UNITED STATES PATENT AND TRADEMARK OFFICE

10/547,337

Office Action Summary	Application No. 10/547,337	Applicant(s) GELUS ET AL.	
	Examiner STEPHEN J. RALIS	Art Unit 3742

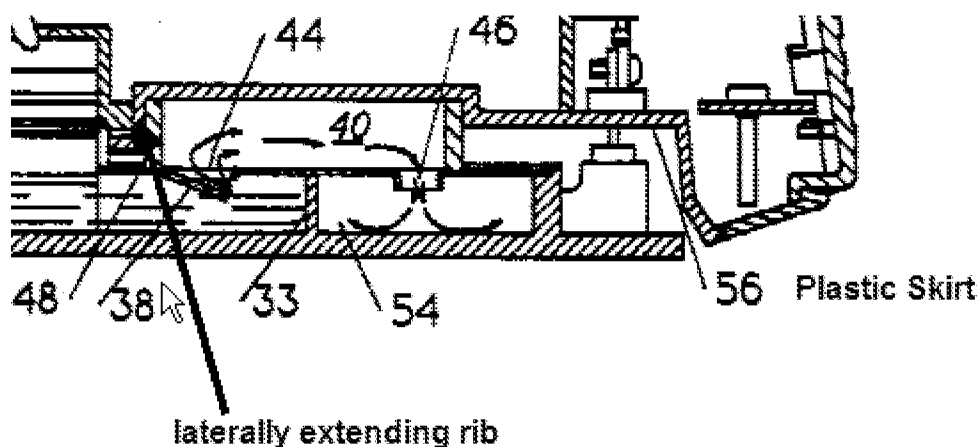
Eckert et al., for example, teaches a steam iron having a bottom surface of a plastic skirt (56) forming the top of a steam chamber (steam boiler chamber 30 extending into the extraction channel 40) comprising a downwardly extending rib that limits the steam chamber laterally (see annotated section of Figure 3 below) and further comprising at least one joint forming a seal (rectangular gasket) between the rib and soleplate (column 4, lines 26-36; see Figure 3). In addition, Eckert et al. teach an embodiment in which a cover (60) forms the top surface of the boiler chamber (30). Therefore since Eckert et al. teach the cover (60) forming the top surface of the boiler chamber (30) and Eckert et al. explicitly teach the skirt (56) may be the roof of the channel (40), which is equivalent to the top surface of the boiler chamber, Eckert et al. clearly teach the skirt (56) being the top surface and part of the boiler chamber (30). Eckert et al. further teaches the advantage of such a configuration provides an extremely low cost means for implementing a steam extraction channel.

12. With respect to the argument that Eckert et al. do not disclose a steam chamber the examiner respectfully disagrees. Eckert et al teach a steam iron having a bottom surface of a plastic skirt (56) forming the top of a steam chamber (steam boiler chamber 30 extending into the extraction channel 40) comprising a downwardly extending rib that limits the steam chamber laterally (see annotated section of Figure 3 above; column 4, lines 26-36; see Figure 3). In addition, Eckert et al. teach an embodiment in which a cover (60) **forms the top surface of the boiler chamber (30)** (column 4, lines 37-40; see Figure 4). Therefore since Eckert et al. teach the cover (60) forming the top surface of the boiler chamber (30) and Eckert et al. explicitly teach the skirt (56) may be the roof of the channel (40), which is equivalent to the top surface of the boiler chamber, Eckert et al. clearly teach the skirt (56) being the top surface and part of the steam chamber (steam boiler chamber 30 extending into the extraction channel 40).

13. With respect to applicant's reply/argument that the gasket of Eckert et al. is not associated with the soleplate, the examiner respectfully disagrees. Eckert et al. explicitly disclose the soleplate (24) extending up to the interface of the skirt (56) as being the same material as set forth by the cross-sectional material cross-hatching. Furthermore, Eckert et al. disclose the joint (gasket) forming a seal between the rib (extension of skirt 56) and the soleplate (24) (see Figure 3). Therefore, Eckert fully meets "at least one joint forming a seal between the rib and the soleplate" given its broadest reasonable interpretation.
